SAFETY RECALL BULLETIN

| SUBJECT: | | | No: | SR-06-004 |
| | FRONT CROSSMEMBER — SAFETY RECALL CAMPAIGN | • | DATE: | September, 2006 |

2007 Eclipse/Eclipse Spyder produced from 6/21/06 to 7/19/06

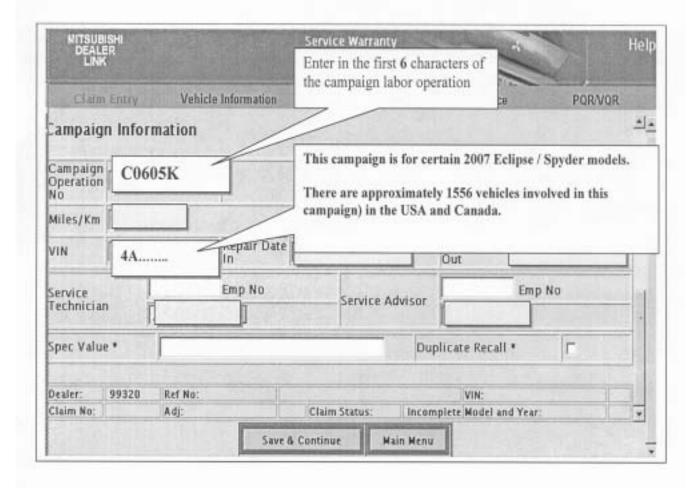
NOTE: If special tool MB991113-01 – ball joint remover is used, it will need to be modified. Grind the opening, in the area shown, just large enough to go around the ball joint.
